**Re: Rapiscan AIT System Radiation Survey Reporting**

<b>Secure 1000 Radiation Emission Measurement</b>	FORM R-0646-1 (Single Pose)
--	---	--------------------------------

## R-0646-1 Addendum (Documentation Errors)

### 1. In Beam Dose Measurement: Survey Table. 1

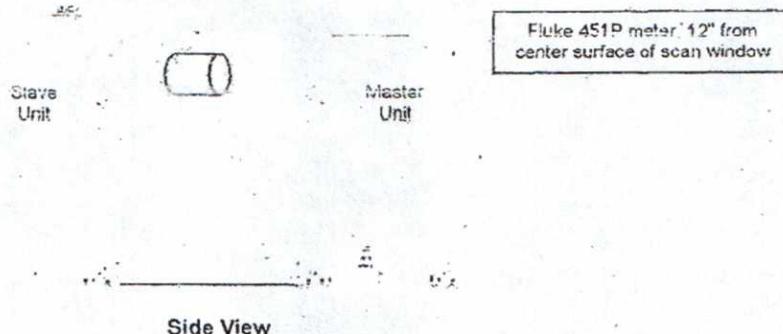
1. No system serial number entered on report. Serial number obtained by accessing corresponding field service records for the system.
2. Technician did not indicate scan time. Correct scan time is 3 seconds.
3. TABLE 1: Incorrect presentation of data in Column 3 for Measured Exposure. Indicated value is 17uR. Corrected value is 1.7uR.
4. TABLE 1: Incorrect presentation of data in Column 6 for Effective Dose. Indicated value is 9.77 uRem. Corrected value is .977 uRem.

The service technician should attend refresher training.

The corrected data indicates this system was operating within expected parameters. No re-survey is required for this system.
